## NOTICE OF NON-PERFORMANCE

On March 24, 2026, Energy Safety conducted an inspection of SCE's WMP initiatives in the vicinity of Calabasas, California in High Fire Threat District (HFTD) Tier 3 and State Responsibility Area (SRA). The inspection report is enclosed herewith. Energy Safety found the following deficiency:

# INSPECTION REPORT

**Photo 1:** Photo of pole ID 1169162E located approximately 65 feet east of the subject tree.

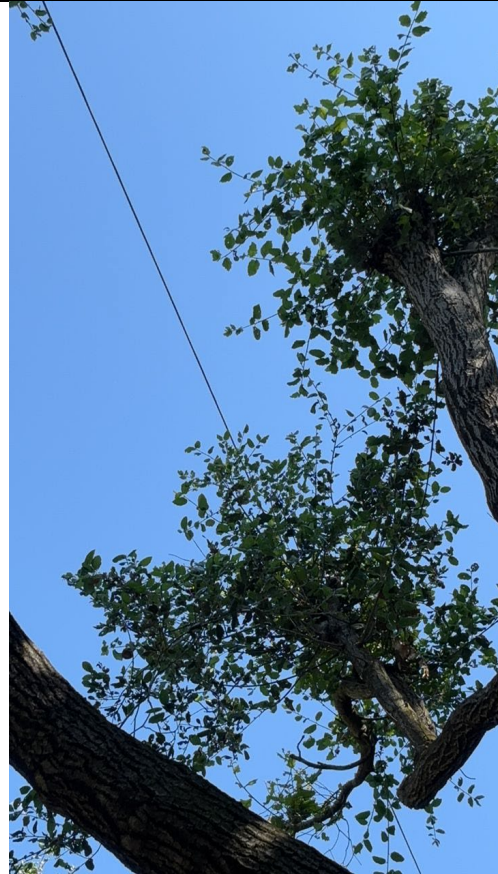
Energy Safety considers this deficiency as "Moderate" because SCE failed to maintain the required minimum clearance distance between vegetation and its conductors, consistent with the requirements of Public Resources Code section 4293. An oak tree was growing within the four-foot clearance distance, and the continued encroachment presents a wildfire risk.

On March 24, 2026, Energy Safety conducted an inspection of SCE's WMP initiatives in the vicinity of Calabasas, California. During the inspection, Energy Safety identified a three-stemmed oak tree growing within the four-foot minimum clearance distance near pole ID 1169162E and near coordinates 34.079224, -118.6878 along Wildwood Drive. The oak tree is located within SCE's defined HFRA and HFTD Tier 3, and SRA. The inspector measured the distance between the primary conductors and the closest branches of the oak tree using a Nikon Forestry Pro II laser range finder. The measured distance was two feet, which is less than the required four-foot clearance. The three-stemmed oak tree has a combined diameter at breast height of 38 inches, is approximately 40 feet tall, and is located 65 feet west of pole ID 1169162E. The inspector's observations are documented in Exhibit A photographs, which are attached to this report. Photo 1 depicts pole ID 1169162E. Photo 2 depicts the oak tree growing under the conductors and encroaching within the four-foot minimum clearance distance. Photo 3 depicts the three-stemmed trunk of the oak tree.
